Docket Item # 7  
BAR CASE # 2008-0013

BAR Meeting  
June 18, 2008

**ISSUE:** Alterations and Signage  
**APPLICANT:** M. Catharine Puskar  
**LOCATION:** 825 N. Washington Street  
**ZONE:** CDX/Commercial

**Update:** Since the May 21, 2008 Board meeting, the applicant has made additional revisions to the project's lighting scheme in response to the Board's concerns. The applicant has also provided information on the proposed lights and poles, and the lighting levels.

Figure 3. Proposed Lighting Plan and New Lamps

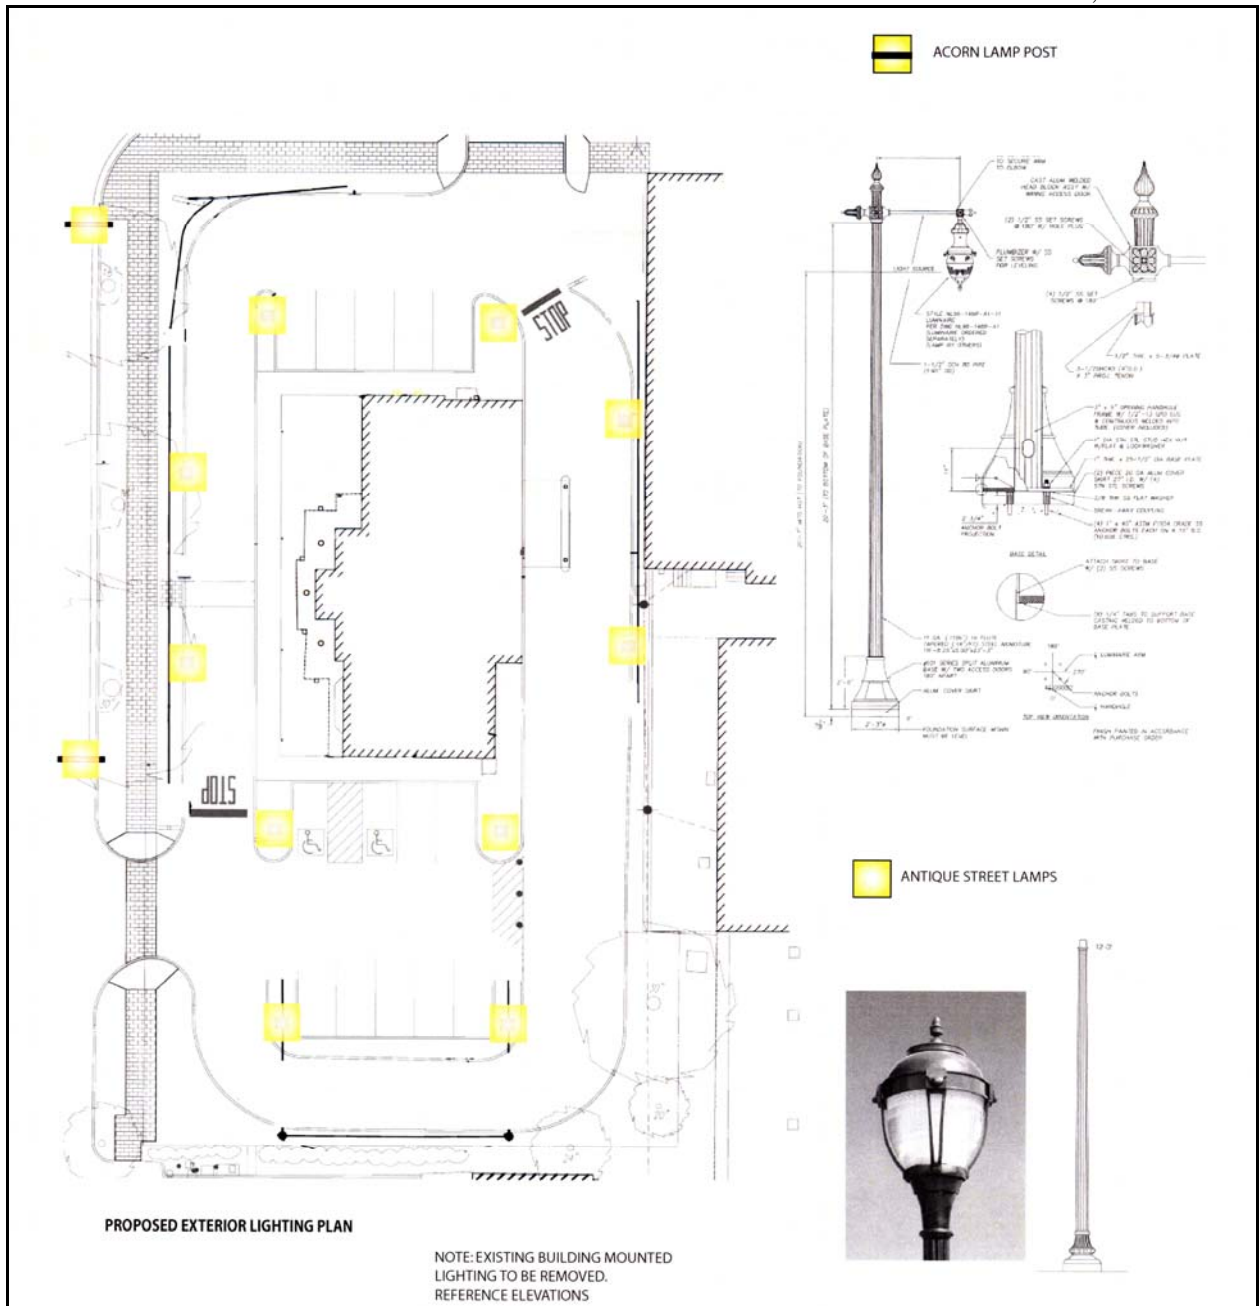
1. Ten (reduced from twelve) freestanding pole lights are proposed in the parking lot and around the perimeter of the property to illuminate the drive aisles and sidewalks that surround the building. The poles will be 12' in height and have been revised in style. The new style has a more traditional street lamp appearance and is manufactured by a company called Antique Street Lamps, with the model being DS7. The fixtures and poles are black metal, with clear glass tops.
2. The existing two street light poles fronting North Washington Street will be replaced with a traditional acorn style light pole manufactured by Union Metal. This is the City approved style for replacement light poles along Washington Street. A cut sheet was provided by the applicant.

The applicant has met with City Staff to discuss the lighting levels within the property and has revised them to reflect the accepted City standards.

Due to its location along the George Washington Memorial Parkway, the manner and treatment of external lighting for this building is important. Staff appreciates the applicant working to revise the amount of lighting, the lighting levels, and the style of the new fixtures and light poles. With the reduction in the number of new freestanding light poles, the new traditional style fixtures, and the decrease in pole height to 12', Staff supports the lighting scheme for the site and parking lot, as well as the two replacement poles fronting North Washington Street. Staff also supports the use of the gooseneck lamps and the continued use of lighting in the overhang to illuminate the new sign next to the main entrance.

Staff also believes that the applicant has made considerable improvement to reducing the lighting levels on the site to acceptable City levels, and will continue to ensure these are met through the plot plan review process.

1. That the applicant work with Staff to determine an appropriate height for the transformer screening wall; and,
2. That the applicant continue to work with Staff to ensure lighting levels on the site are appropriate and meet acceptable City standards.

Figure 4: Proposed Alterations on North Elevation

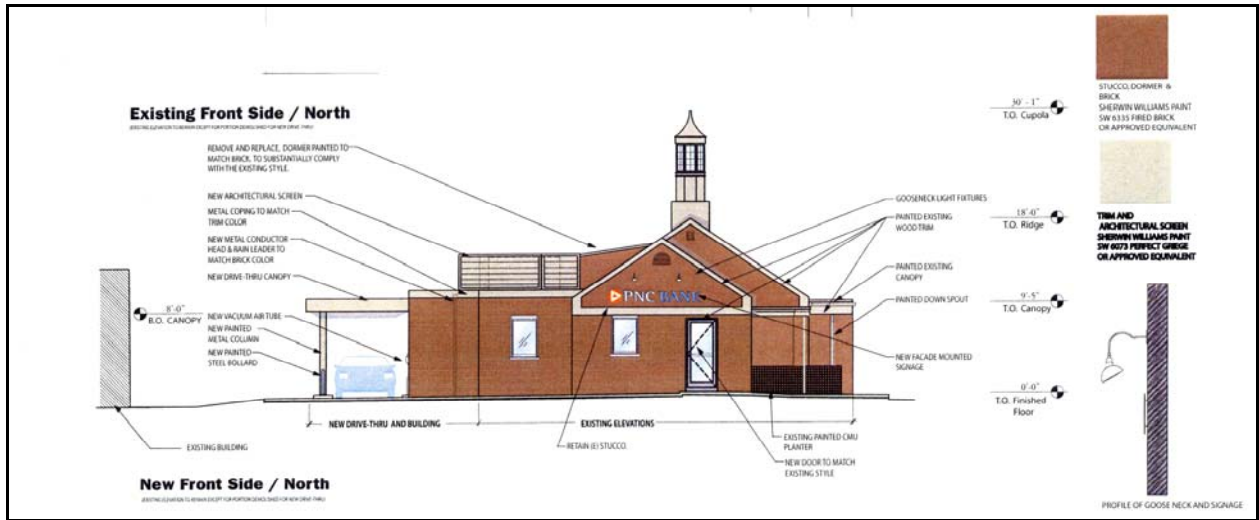
The Applicant is proposing to install two (rather than the three as previously shown) new gooseneck lamps within the north gable end of the building to provide lighting over the new channel lettering signs that read "PNC BANK" with logo. The applicant has deleted the internal illumination. The lamps will be installed above the signage. The applicant provided manufacturer information on the gooseneck lamps.
